RE: SITE PLAN – ADMINISTRATIVE DEVELOPMENT FACILITATION TEAM TRACT 52-A, UNIT 2 TRACTS ALLOTTED FROM TOWN OF ATRISCO GRANT PR-2018-001681 SUNSET GARDENS

Development Facilitation Team (DFT) – Review Comments

Project No: PR-2018-001681 Date: 03/06/2024 Agenda Item: #1 Zone Atlas Page: MX-L

Application For: SI-2024-00271 – SITE PLAN DFT

BUILDING 1 SOUTH COLOR ELEVATION

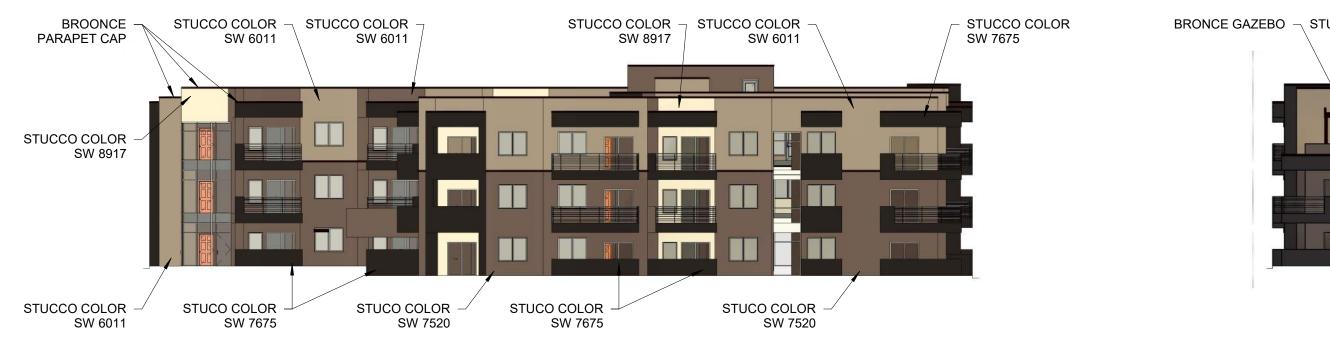
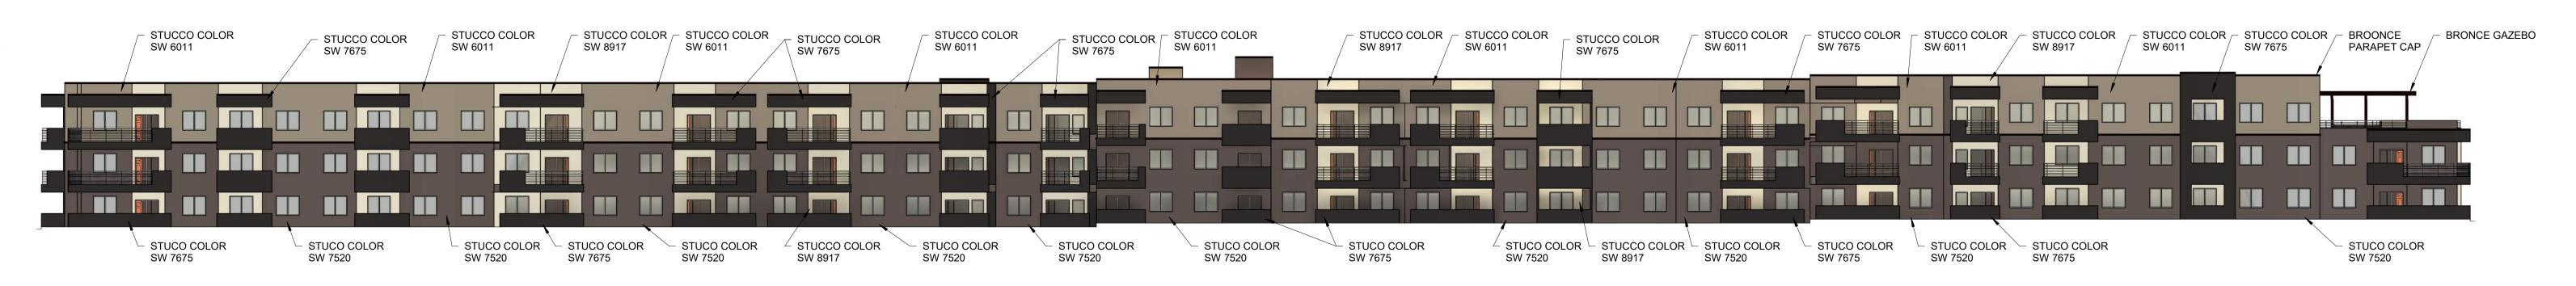
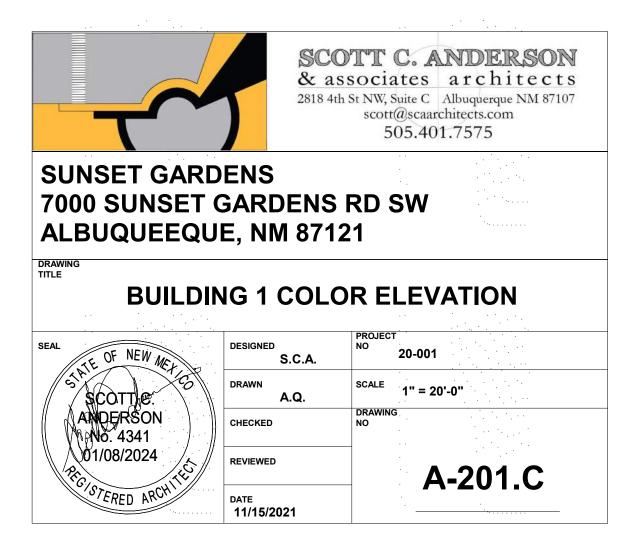
Please demonstrate how this section is met in a comment response letter as well as notes on the plans. Provide color elevations in the site plan set. Provide vertical and horizontal dimension lines on the elevations.

- Facades shall change in massing and form as specified below to visually break up the building. Each front and side façade shall meet all of the following requirements or provide justification that the intent of this section is achieved by an alternative design approach.
 - 1. The façade shall have at least one element that is recessed or projected from the façade by at least 6 inches and that is 2 feet in width for every 30 feet of facade length. Please articulate how the project complies with this code.
 - 2. RESPONSE: See updated Elevation sheets.
 - 3. Each street-facing façade shall be designed with more than one building finish material or color. Provide color elevations in the site plan set to confirm compliance with this code.

RESPONSE: See updated Elevation sheets both black and white and in color.

RESPONSE: See updated color Elevation sheets.
